# PATHFINDER

Ref: Source Material License No. SUA-442, Docket No. 40-6622

## **Discussion of Changes in the ACL Application.**

<b>PATHFINDER</b> PATHFINDER MINES CORPORATION SHIRLEY BASIN, WYOMING		
FIGURE 12-7. NORTHEAST SPRING CREEK AREA PIEZOMETRIC SURFACE AND WATER QUALITY		
DRAWN BY: TGM	DATE: 7-2001	SCALE: 1"=400'
		FIG12_7.DWG
REVIS. NO:	HYDRO-ENGINEERING, L.L.C.

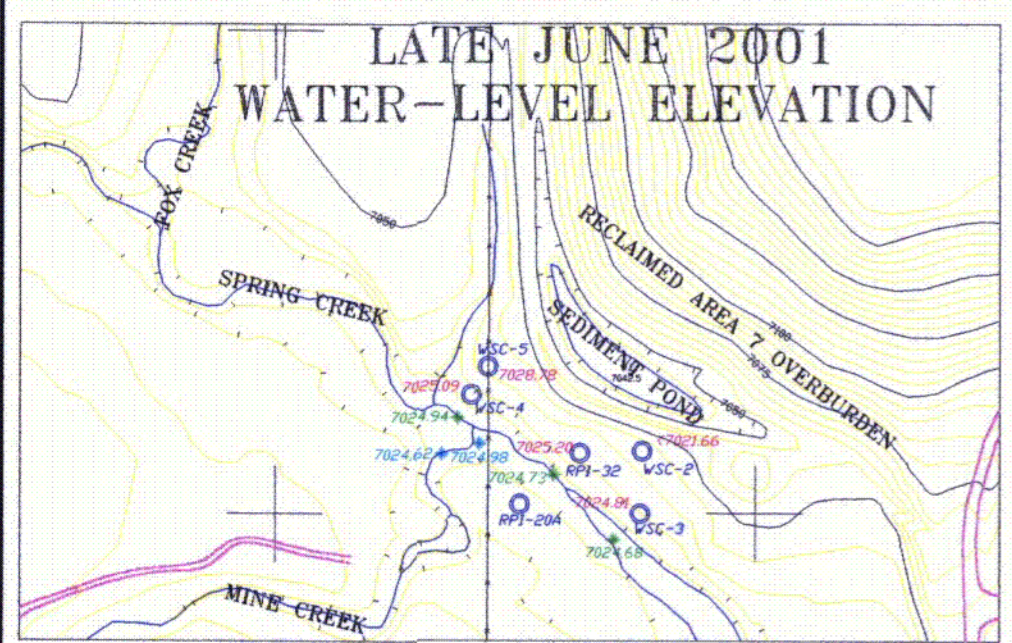
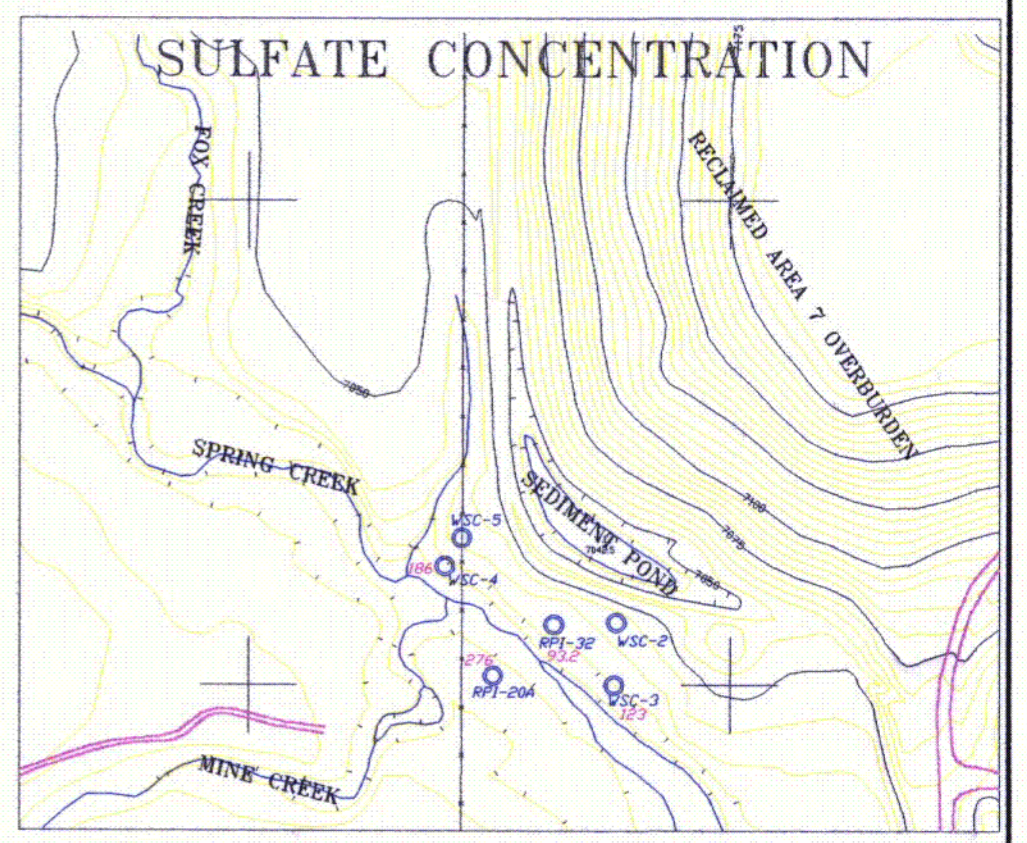
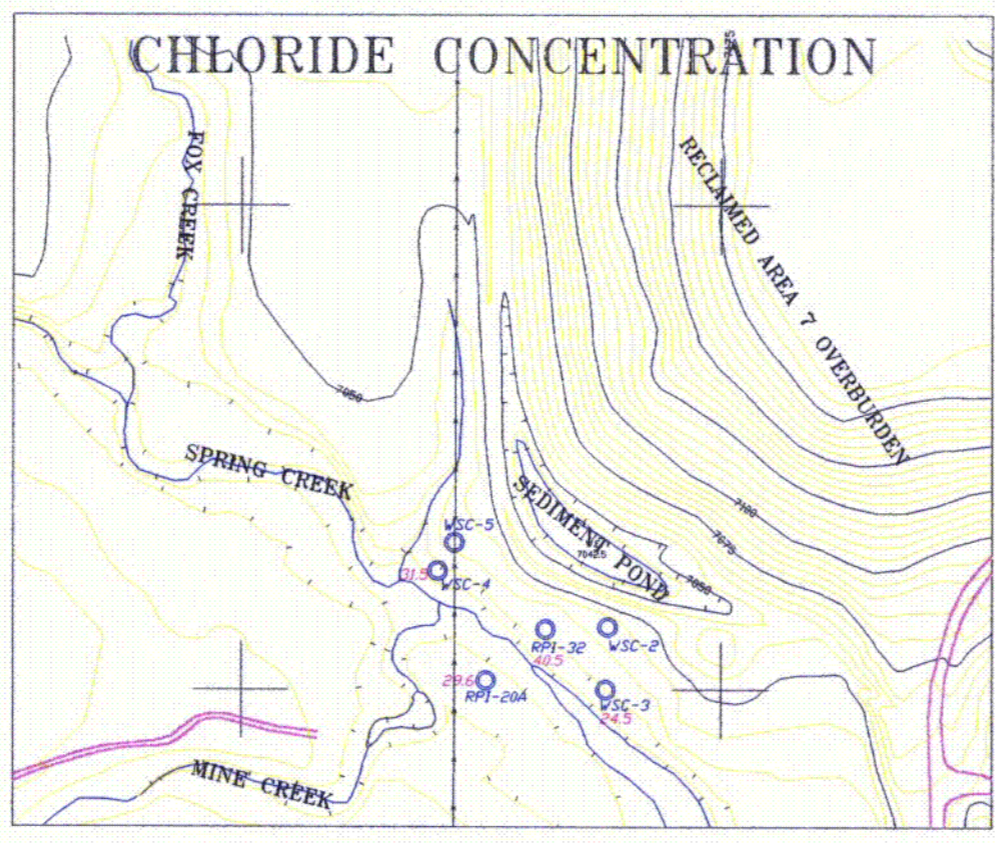
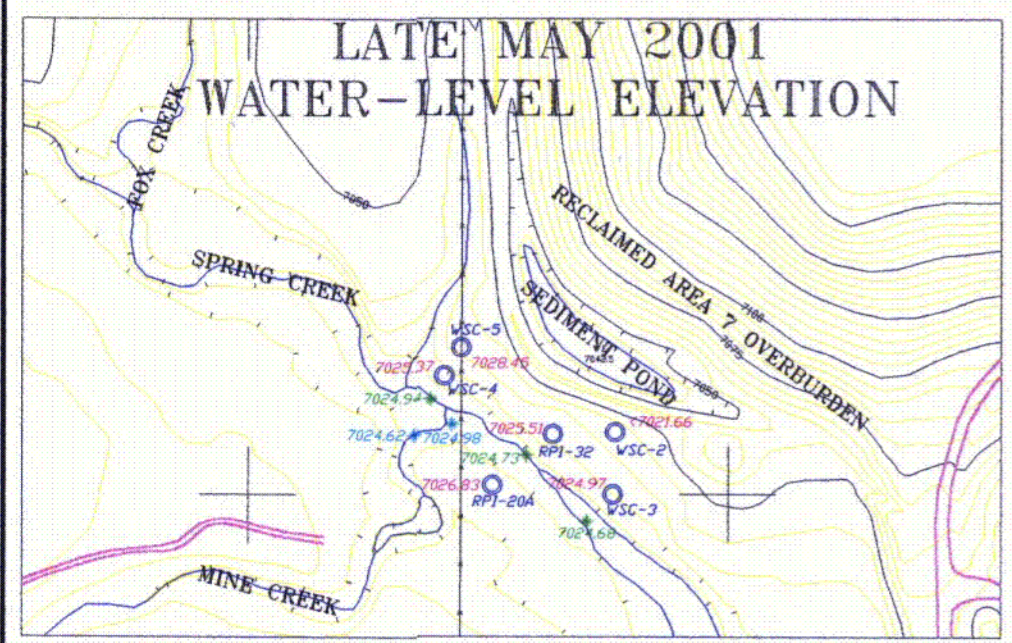
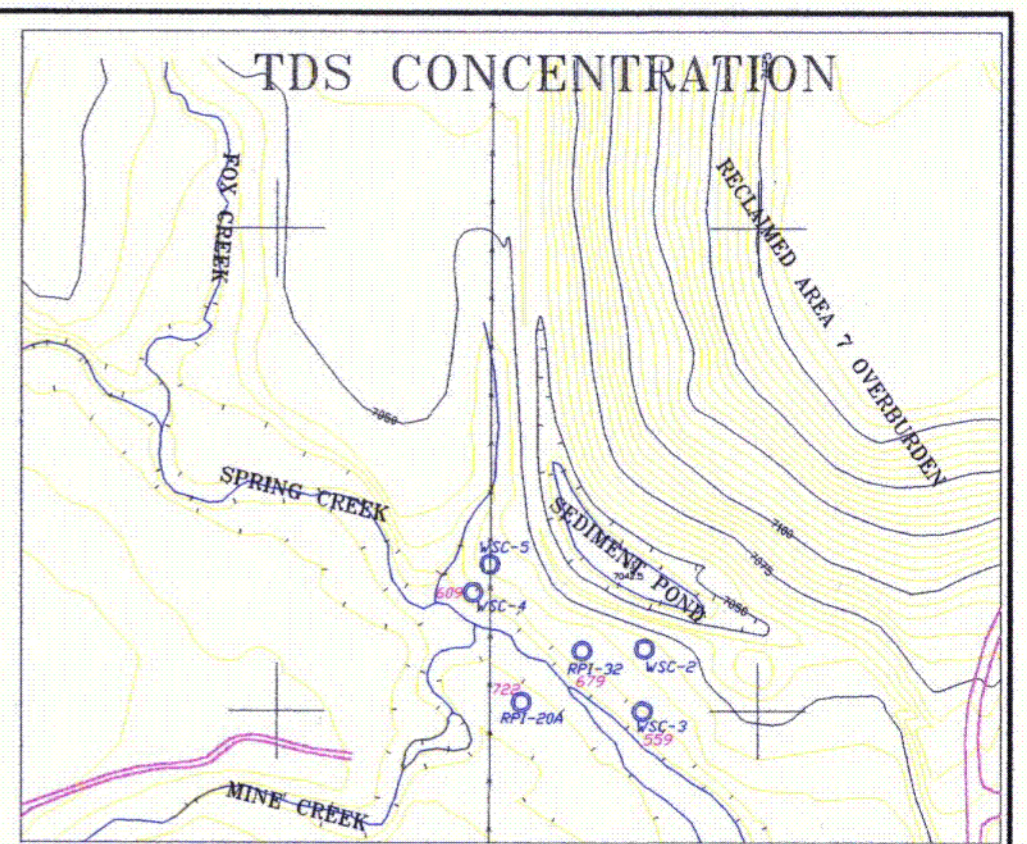
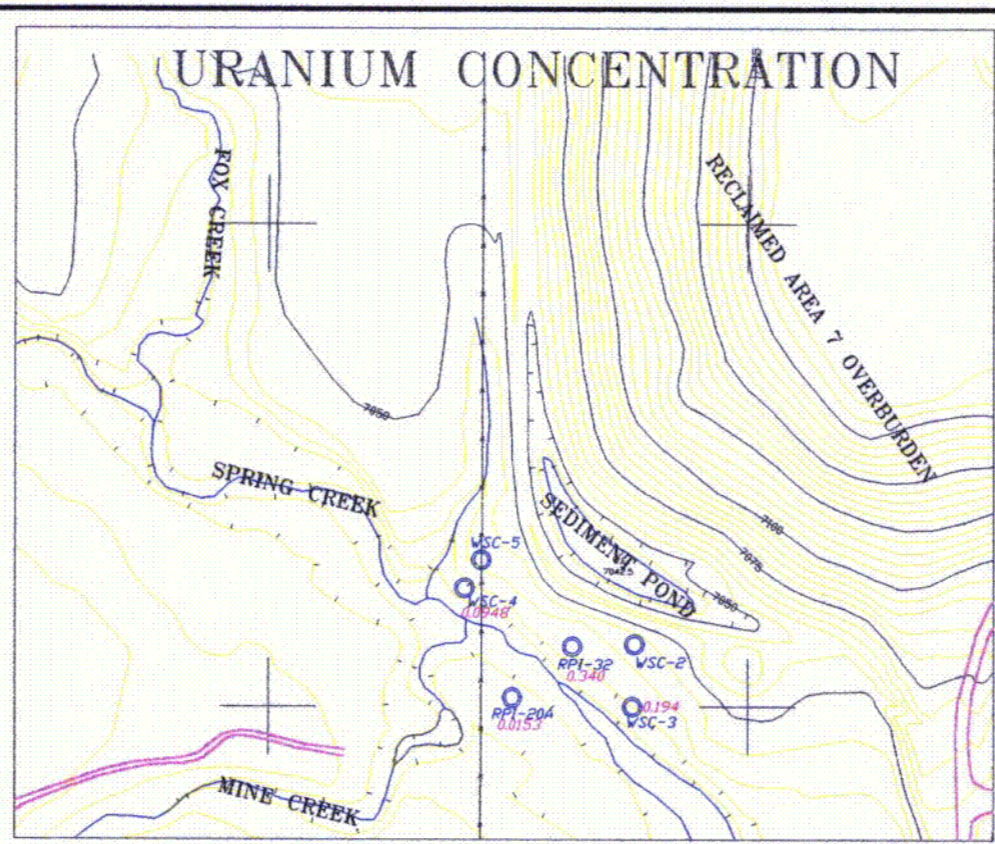
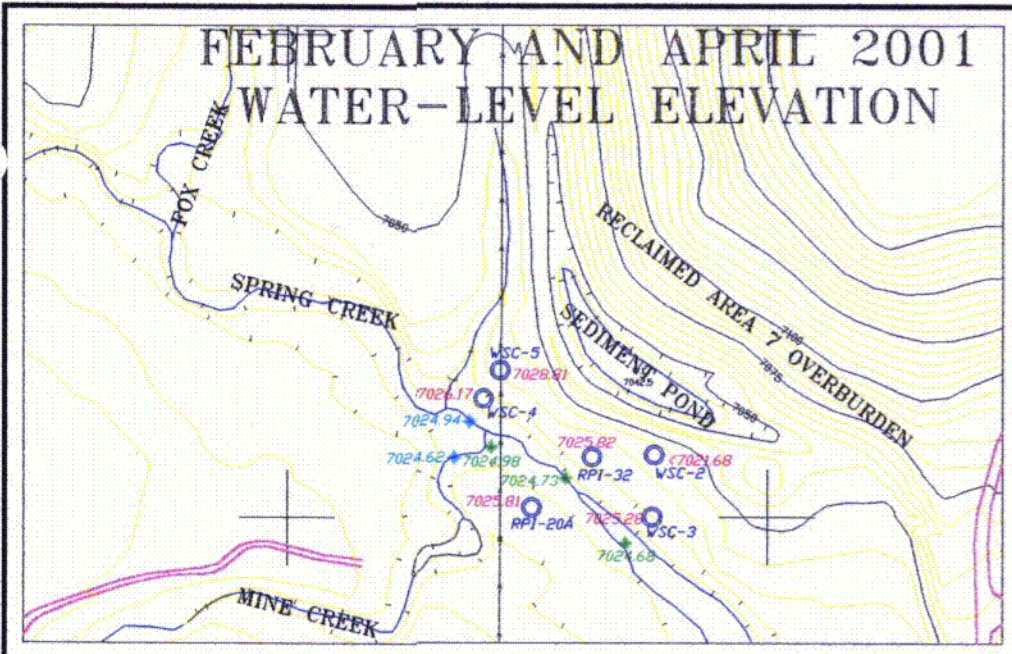
**Comment 8: Potential migration under Spring Creek.**

The additional wells on the northeast side of Spring Creek were used to evaluate potential migration of seepage across the creek. Figure 1.2-7 presents water-level elevations for the Surficial Aquifer in the vicinity of the confluence of Mine Creek and Spring Creek. Also shown on Figure 1.2-7 are recent concentrations of uranium, chloride, TDS and sulfate. The lithology in the newly installed wells indicates a moderately permeable Surficial Aquifer adjacent to the Spring Creek, with no shallow sands in the WSC-2 area and sands that are higher in well WSC-5. With the absence of shallow sands in the vicinity of well WSC-2, and the very limited saturation in the vicinity of well WSC-5, the Surficial aquifer does not appear to be contiguous and may be absent while moving to the north and east from Wells WSC-5 and WSC-2. There is likely some local recharge through the reclaimed Area 7 overburden and the sediment pond at the toe of the overburden pile that supports the water levels in the limited Surficial aquifer north of Spring Creek.

The three water-level maps presented in Figure 1.2-7 indicate a gradient towards Spring Creek from both the northeast and southwest sides. The water-level elevation at three points along Spring Creek and the base of the drainage at two points on Mine Creek were surveyed in late June of 2001. The base of drainage points on Mine Creek approximate water levels for groundwater discharge to Mine Creek. Comparing the water-level elevation in Spring Creek and adjacent wells indicates that flow is convergent to Spring Creek. Well RPI-20A is located opposite of well RPI-32 near Spring Creek and the intermediate water level elevation of Spring Creek between the two wells is more than 0.47' lower than either well. The water level in wells WSC-4 and WSC-3 is also higher than adjacent points on Spring Creek, indicating that flow is towards Spring Creek. During periods of snowmelt or runoff, the increased stage may result in Spring Creek temporarily becoming a losing stream through this reach. Under these circumstances, the water recharging the Surficial aquifer will be characteristic of surface water.

The water quality in wells northeast of Spring Creek shows some elevated concentrations in comparison to typical background. Figure 1.2-7 presents concentrations of uranium, chloride, TDS and sulfate for wells RPI-20A, RPI-32, WSC-3, and WSC-4. Wells WSC-2 and WSC-5 could not be sampled because of low water levels. The uranium concentration in wells WSC-4, RPI-32 and WSC-3 is appreciably greater than that in well RPI-20A, which is located on the opposite side of Spring Creek. Well RPI-20A has shown severe seepage impacts in the past, but uranium concentrations have been less than 0.1 mg/l since mid-1992. Concentrations of chloride and TDS are similar for the previously mentioned wells, while the sulfate concentration for well RPI-20A is appreciably greater than wells north of the creek.

<b>PATHFINDER</b> PATHFINDER MINES CORPORATION SHIRLEY BASIN, WYOMING		
FIGURE 1.3-8. SELENIUM CONCENTRATION FOR THE SURFICIAL AQUIFER, 1999		
DRAWN BY: TGM	DATE: 6-2001	SCALE: 1"=700'
		FIG13_8.DWG
REVIS. NO:	HYDRO-ENGINEERING, L.L.C.

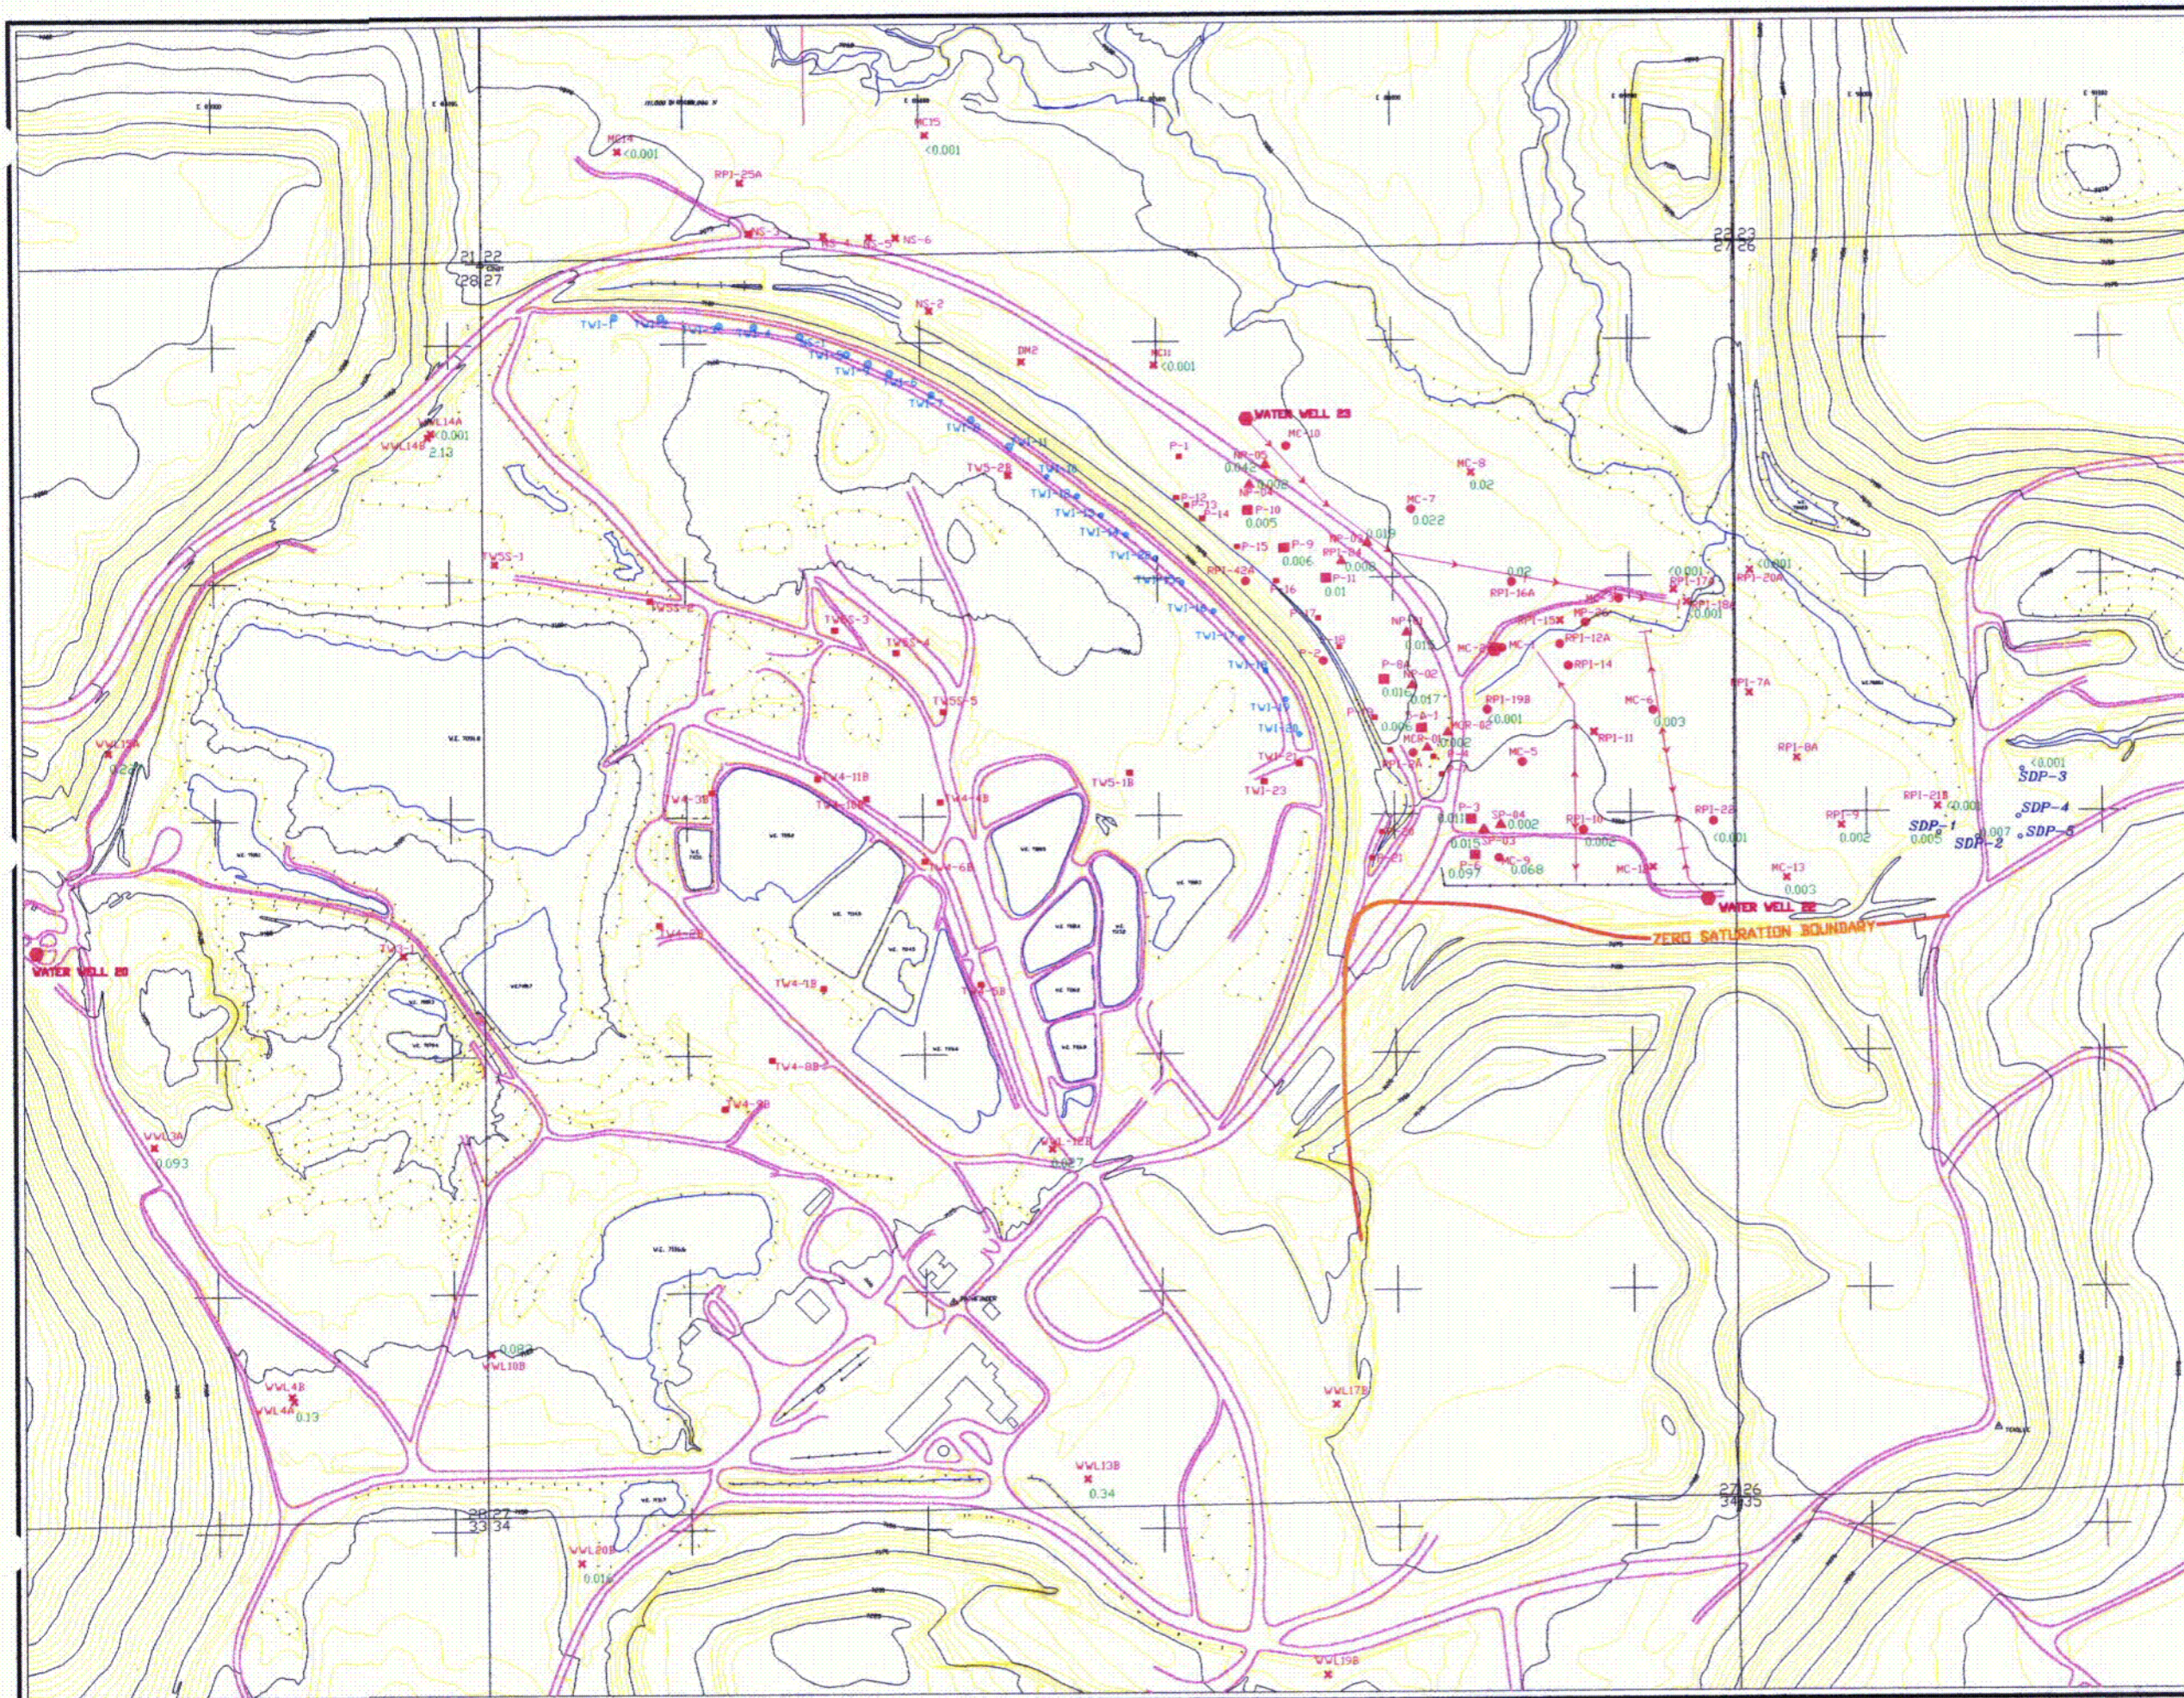
**Comment 1: Substitution of SDWA MCL for selenium.**

**Discussion:** Selenium has been added as an ACL constituent with the site standard of 0.01 mg/l as the applicable standard. This change is included throughout the document.
